To: All Plan Holders of Record

Re: *Addendum No. 1*
Lake County Executive Airport Terminal
Lake Development Authority

Date: June 17, 2024

SCALE:	As indicated
CONTRACT NO:	220656
SHEET	A3.01

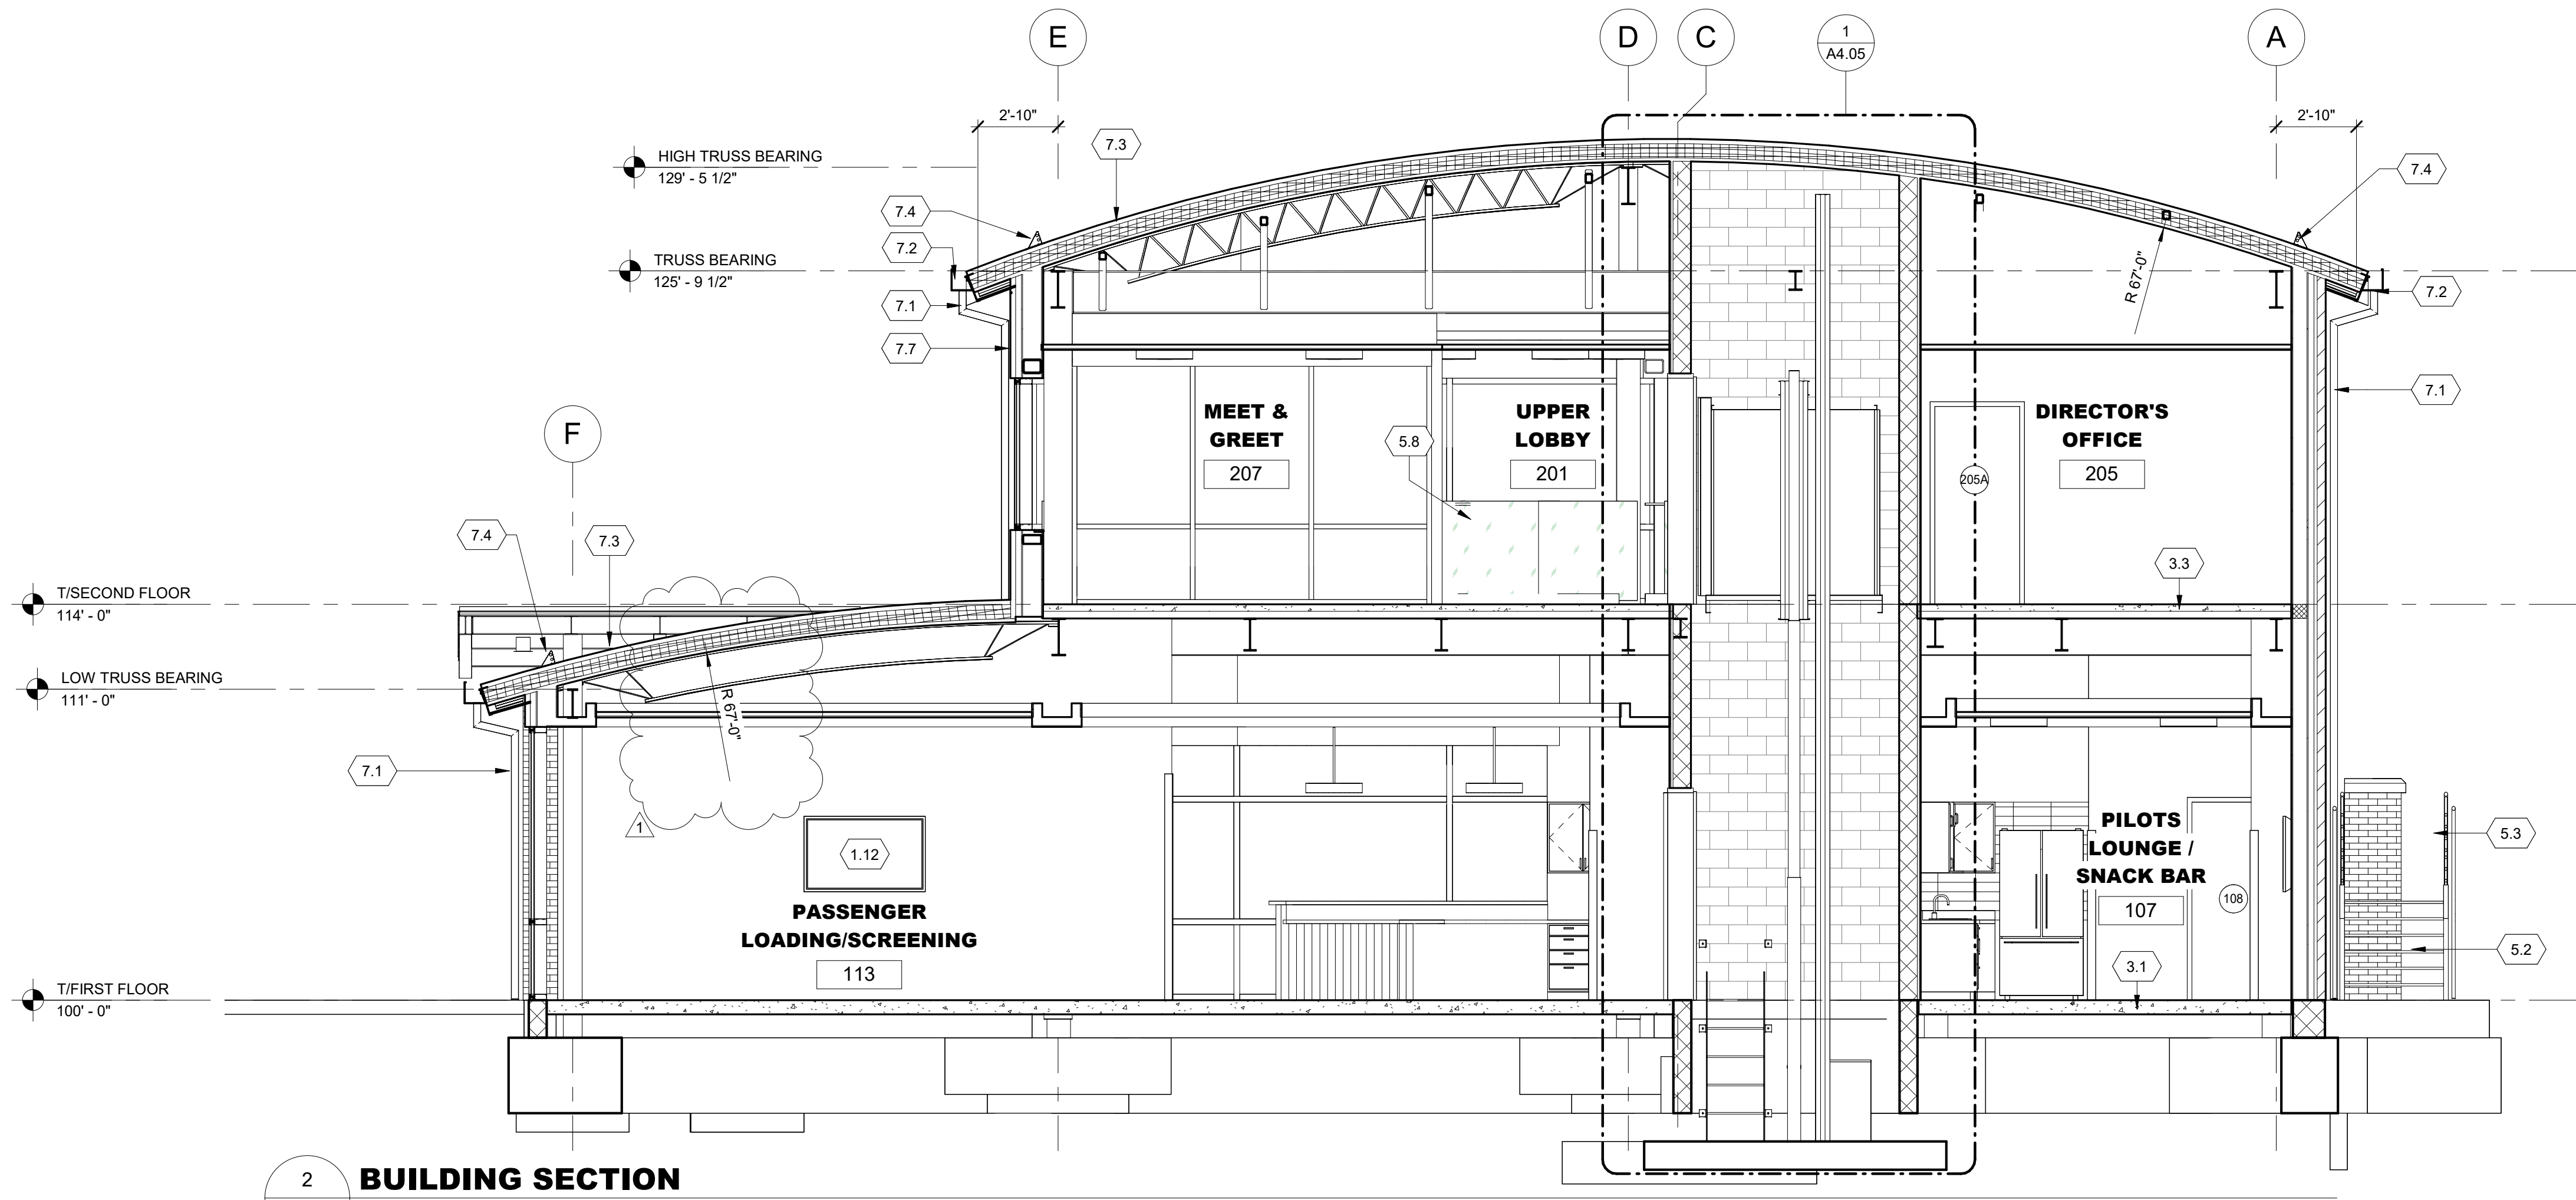
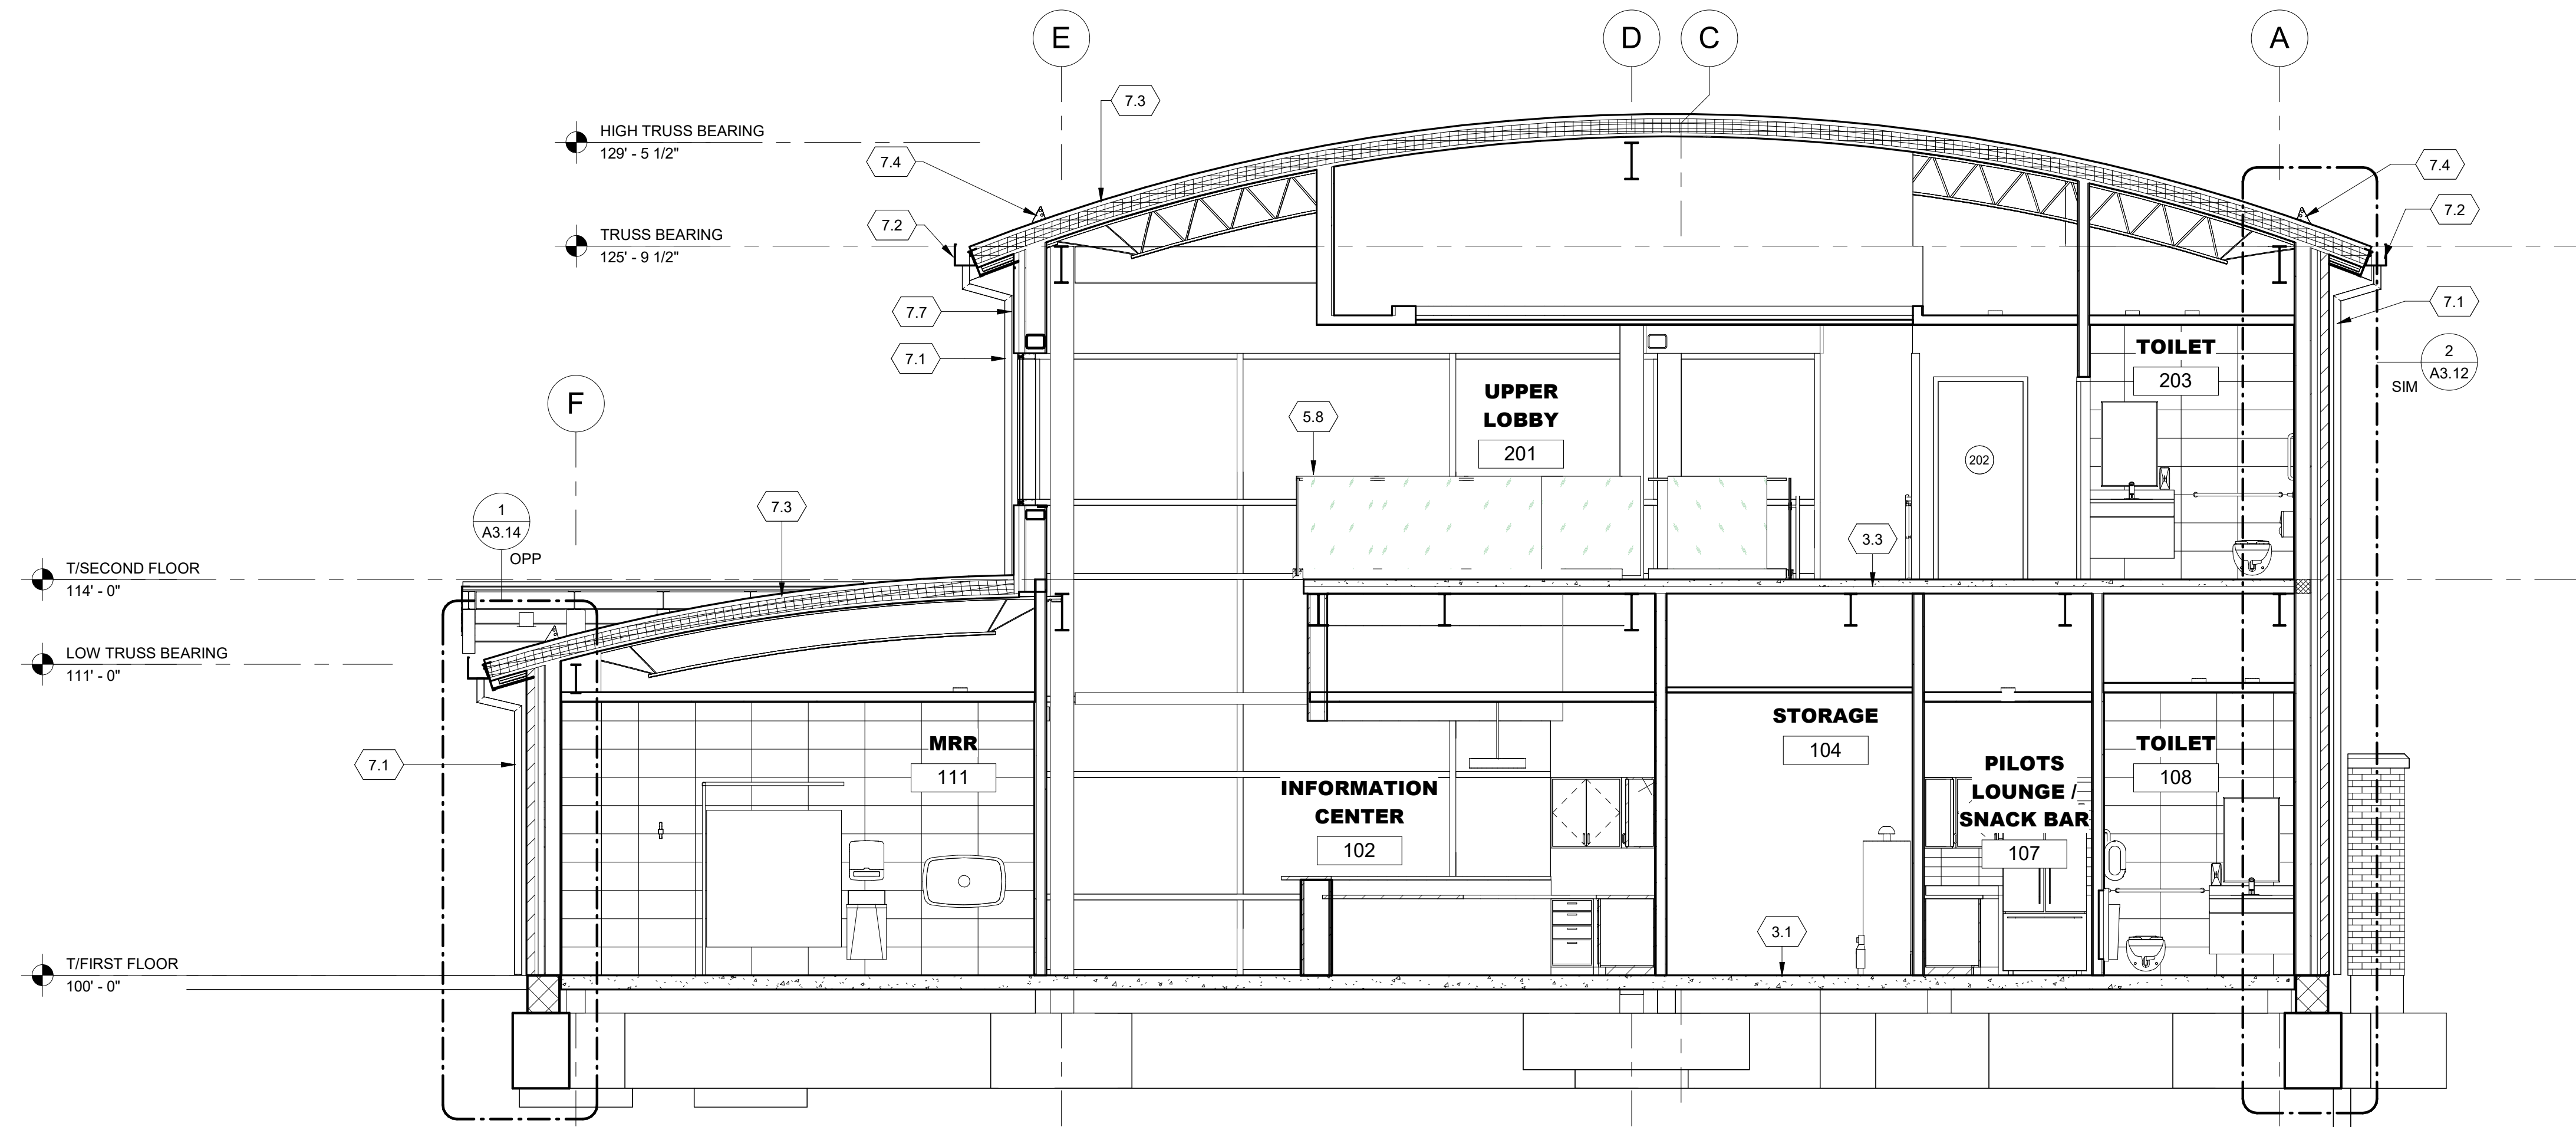
Reissued: A3.01 Added radius dimension to lower roof on 2/A3.01.

3 **ENLARGED PLAN**
A4.01 1/2" = 1'-0"

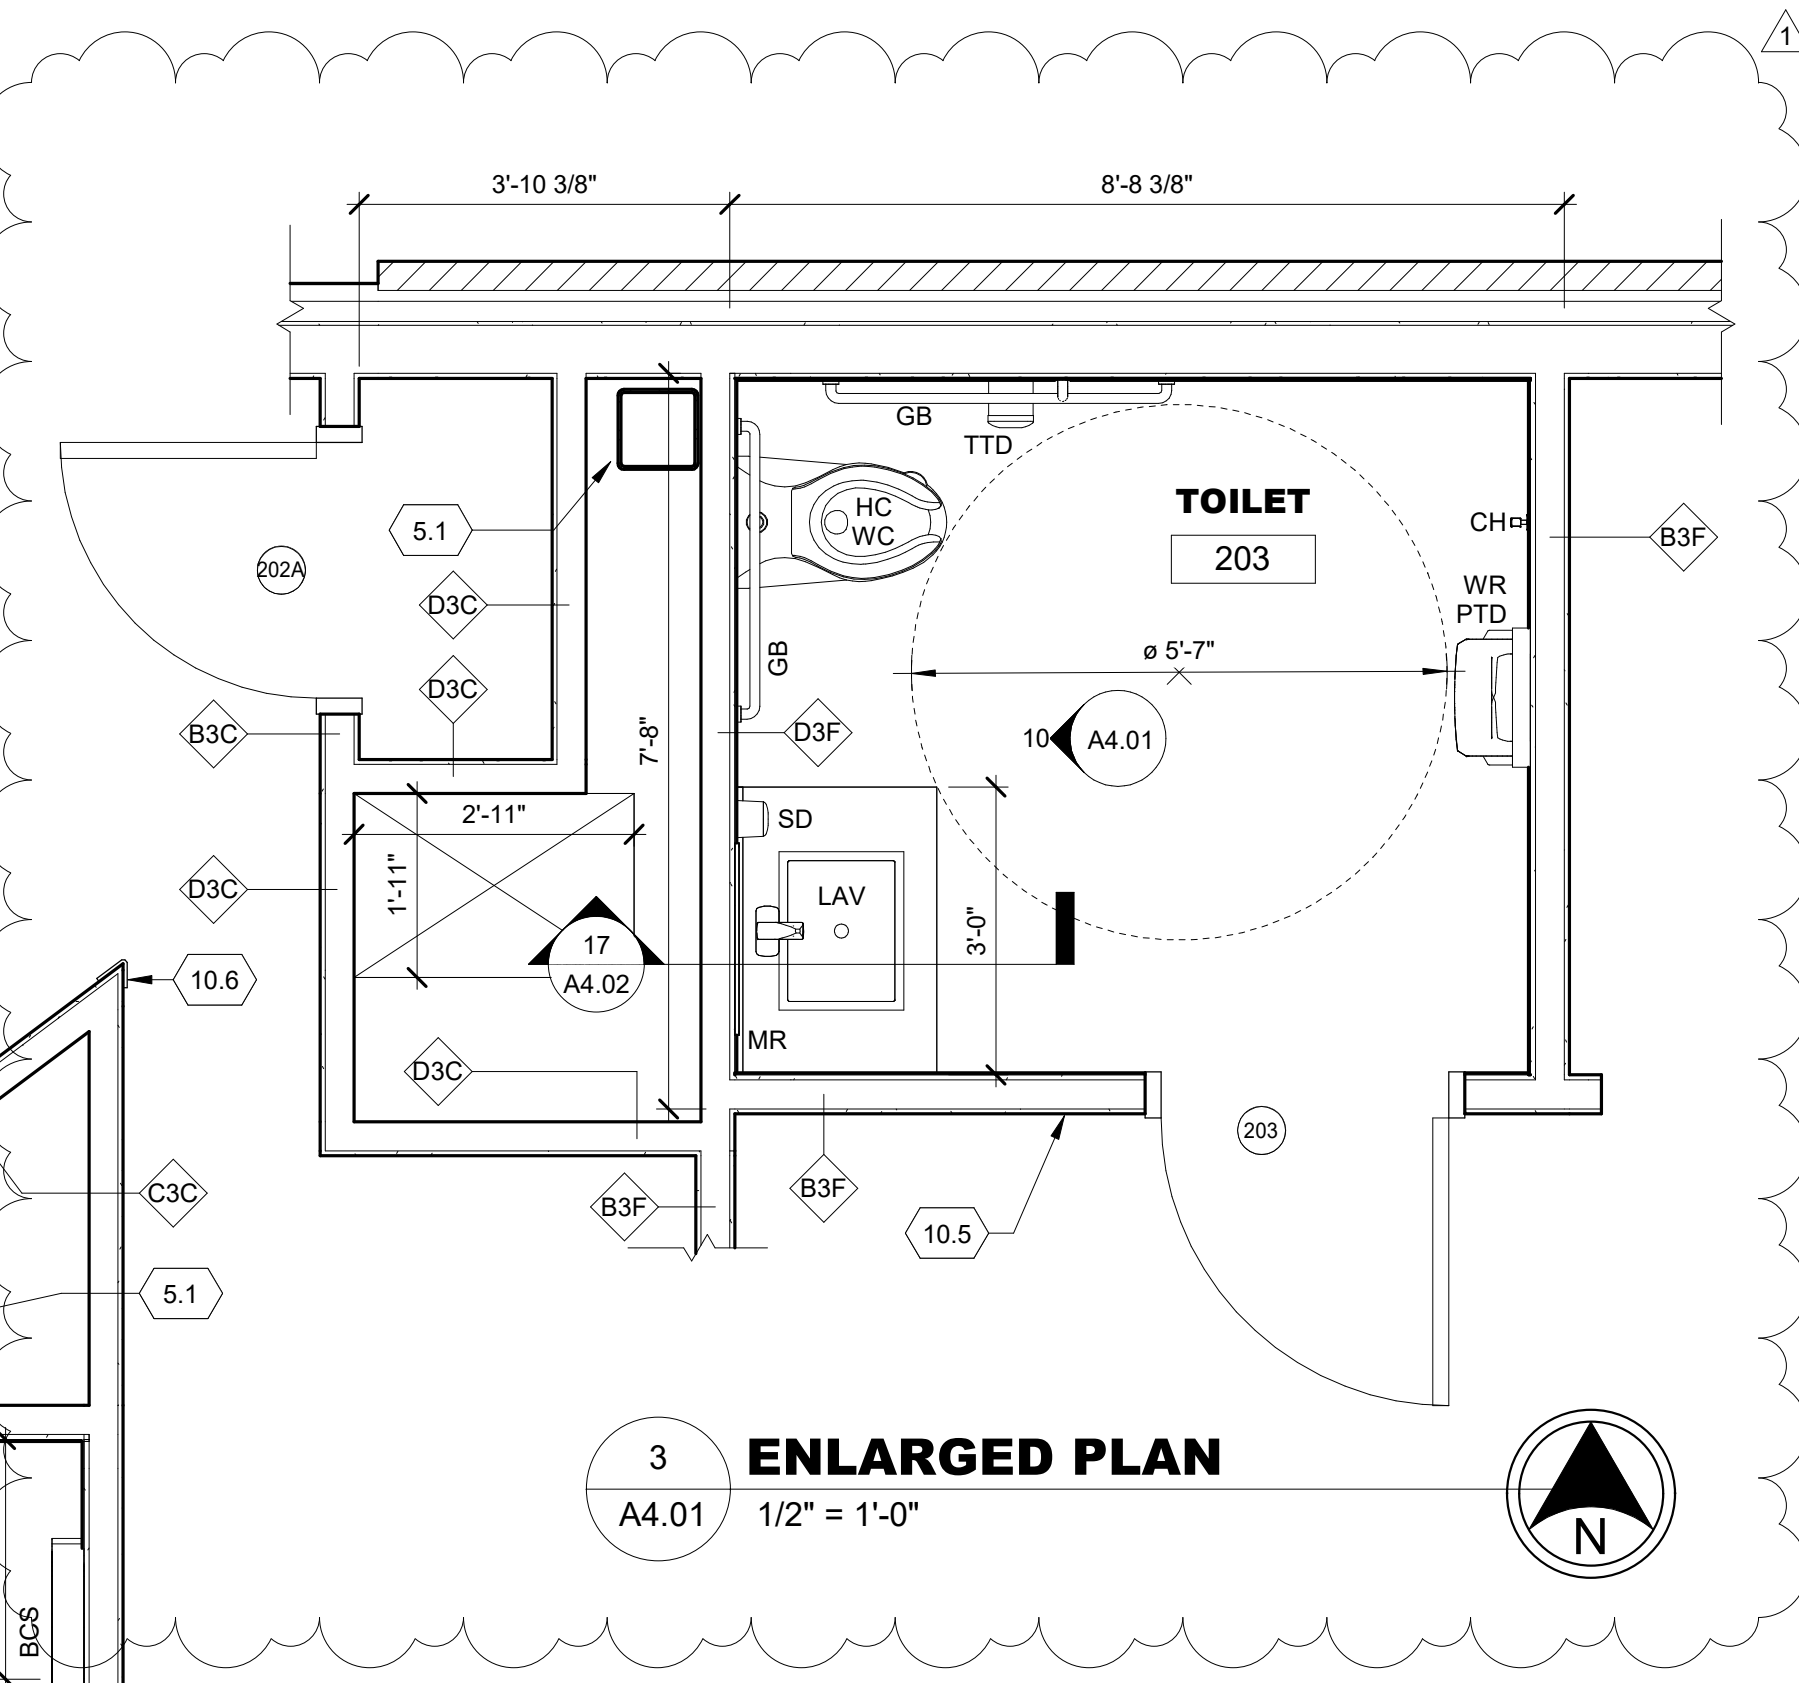
Reissued: A4.01 Updated 3/A4.01 for HVAC penetration.

SCALE:	As indicated
CONTRACT NO:	220656
SHEET	A6.01

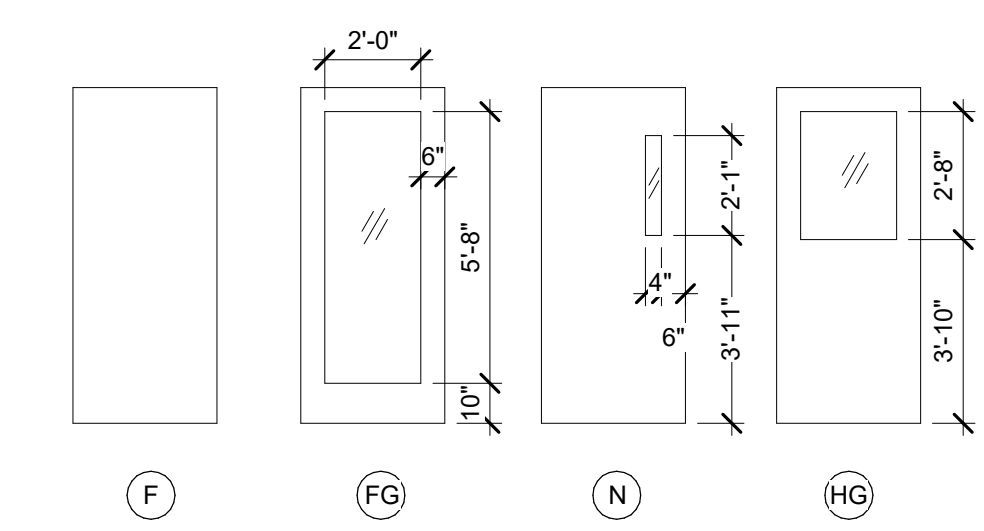
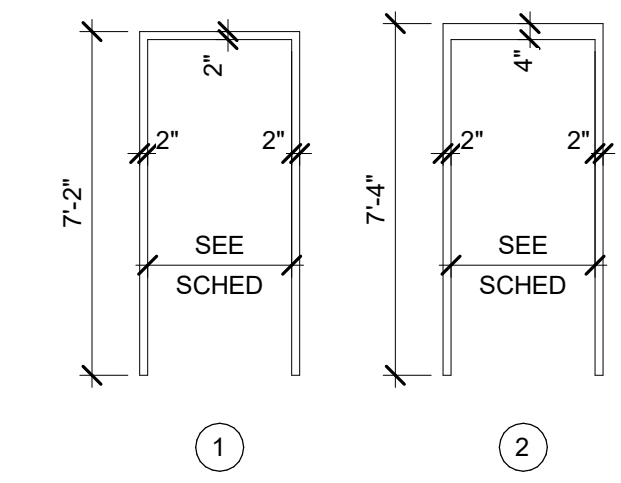
Reissued: A6.01 Updated Door Schedule to remove Meet and Greet 201 door and adjusted 202A door.
